September 6, 2016

Subject: Comments from the RM11E Group on the Portland Harbor Superfund Site Proposed Plan and Feasibility Study

The River Mile 11 East Group (RM11E Group)¹ is providing the following comments on the Proposed Plan (PP) and Feasibility Study (FS) that were issued by the U.S. Environmental Protection Agency (EPA) for the Portland Harbor Superfund Site (PHSS) on June 8, 2016. The comments build upon those the RM11E Group provided to EPA for transmittal to the National Remedy Review Board (NRRB) and the Contaminated Sediments Technical Advisory Group (CSTAG) (collectively, the Boards) in October 2015. The RM11E Group's comments are based primarily on the Supplemental Remedial Investigation and Feasibility Study (Supplemental RI/FS) work that has been and continues to be conducted by the RM11E Group under the 2013 Administrative Settlement Agreement and Order on Consent (AOC) for Supplemental RI/FS Work with EPA (RM11E AOC).² Thank you in advance for considering these comments as you develop the Record of Decision (ROD).

Figure 9.5
 July 15, 2015

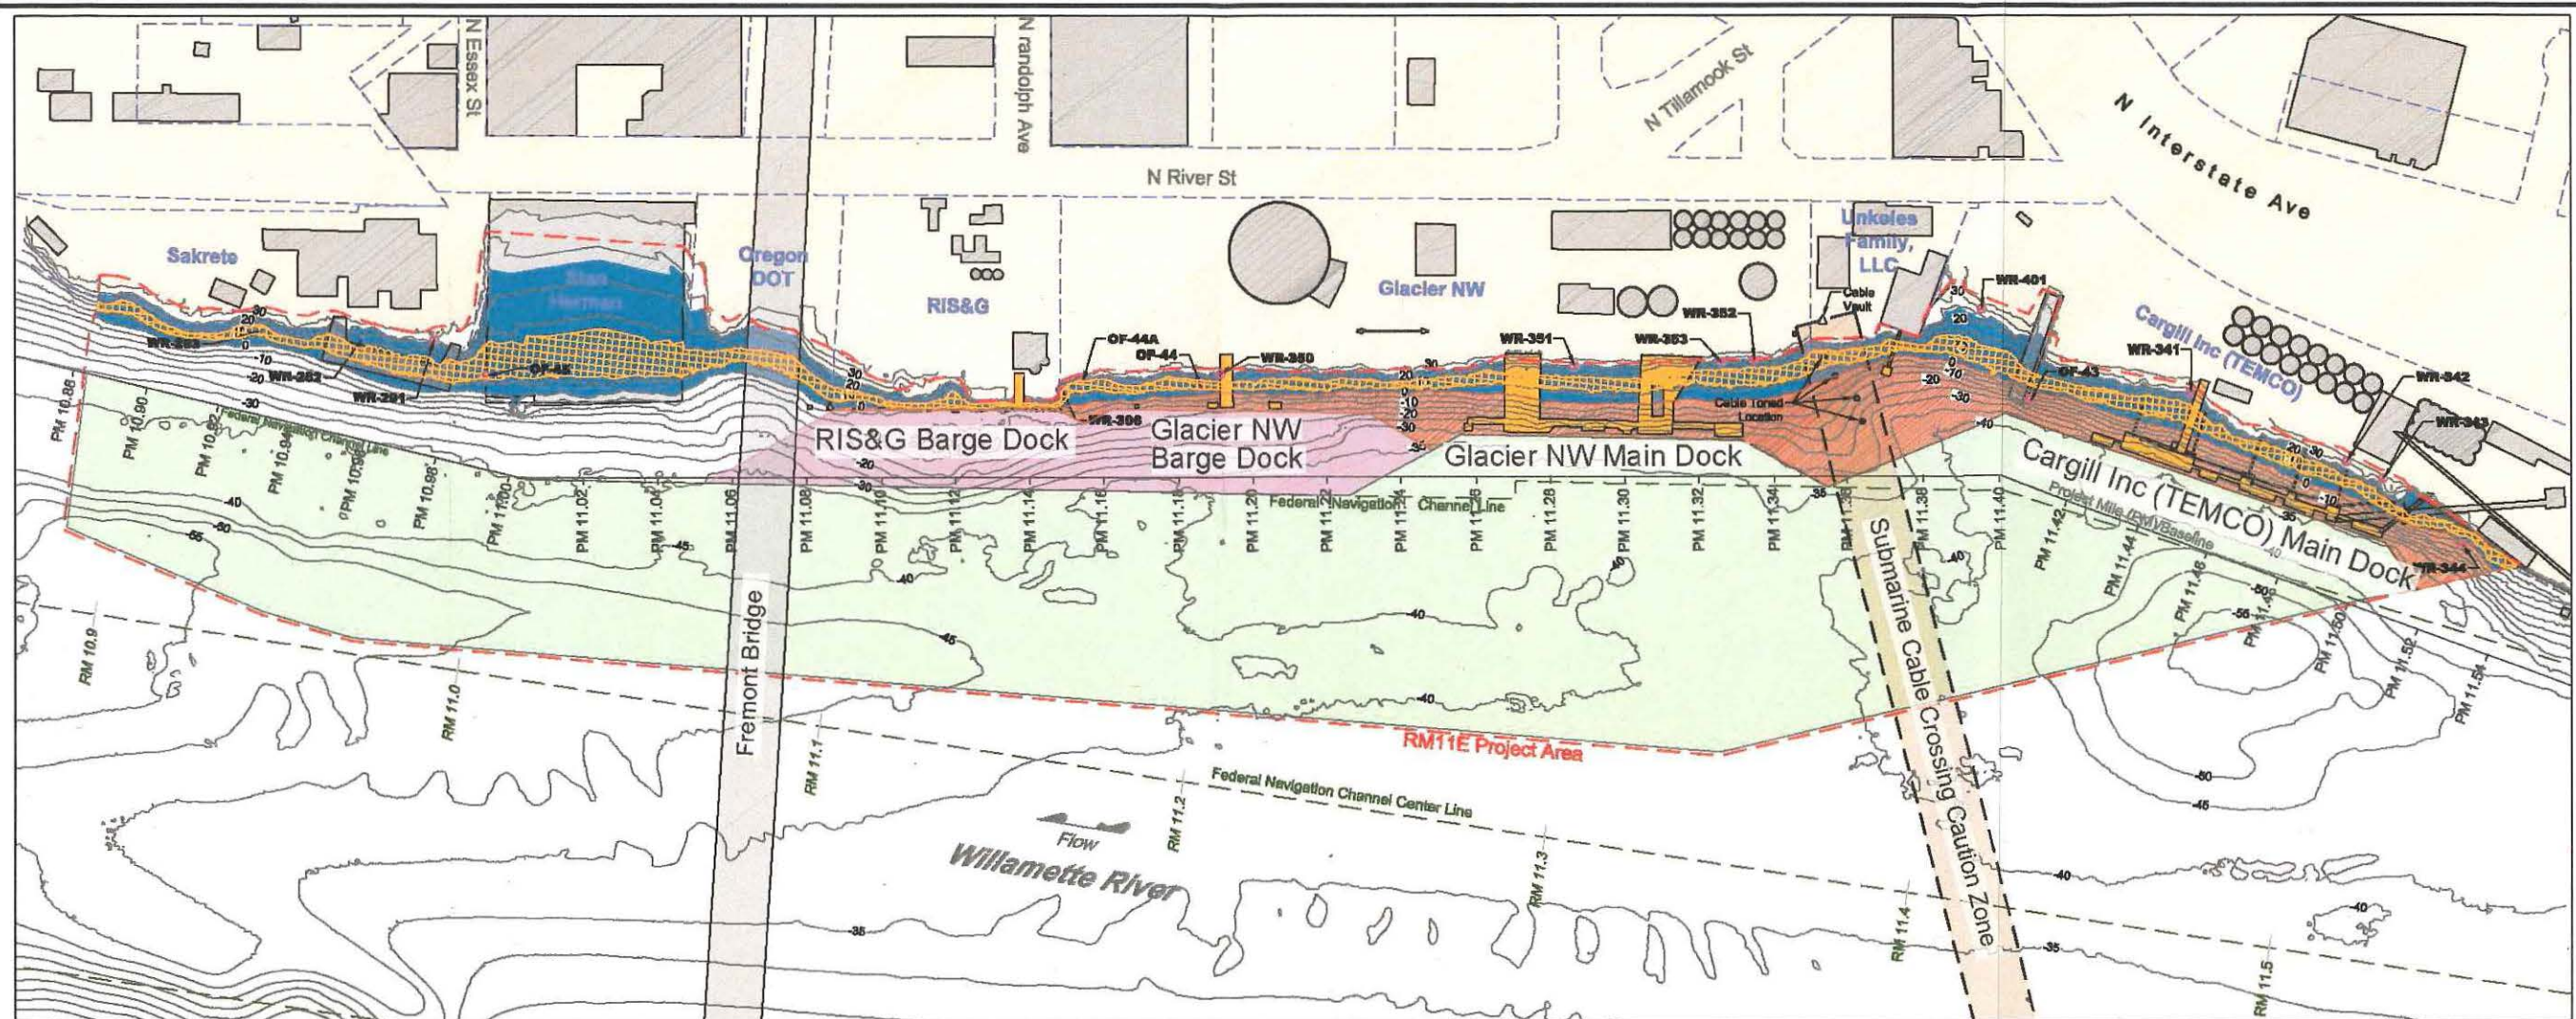
1. Facility Operations (Figure 9.1)
2. Navigation Clearance (Figure 9.2)
3. Construction Access (Figure 9.2)
4. Submarine Cable Crossing (Figure 9.2)
5. Groups of Vertical Pile Remnants (Figure 9.3)
6. Large Undifferentiated Debris (Figure 9.3)
7. Oversteepened Slopes (Figure 9.4)
8. Structure Stability and Capacity (Figure 9.1)
9. Vessel Propeller Wash (Figure 9.5)
10. Wave Action (Figure 9.5)
